TE Connectivity

Product Change Notification: PCN-26-292457

Product Description: (Text limited to 120 characters)
DEUTSCH DT04-4P-XXXX Product Drawing Clarification

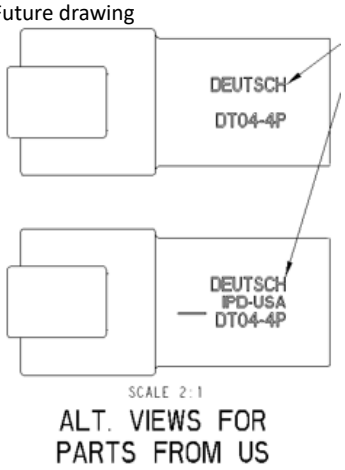
The Industrial and Commercial Transportation business unit of TE Connectivity is making a minor drawing change to clarify the alternate geometries from the US for the product drawing(s) listed below.

Current Note 7

7 MARKING FOR PARTS PRODUCED IN US:
-DATE CODE:
YEAR TO BE LAST NUMERICAL DIGIT, EX: 1 = 2021
MONTH USES SEQUENTIAL ALPHA CHARACTERS, EX: A = JANUARY
-DEUTSCH

Dear Customer, we hereby inform you of this drawing change. The change is necessary to clarify the alternate geometries from the US and note 7 to include these. The change does not impact performance. IMPORTANT: This change is limited to updating the drawing to reflect existing production parts. No changes to the product or tooling are being made. Shipments of both configurations may be mixed.

Future Note 7

7 MARKING FOR PARTS PRODUCED IN US:
-DATE CODE:
YEAR TO BE LAST NUMERICAL DIGIT, EX: 1 = 2021
MONTH USES SEQUENTIAL ALPHA CHARACTERS, EX: A = JANUARY
-DEUTSCH
-MIDDLE LINE OF TEXT MAY BE "INDUSTRIAL", "IPD-USA" OR BLANK WITH A RAISED LINE.
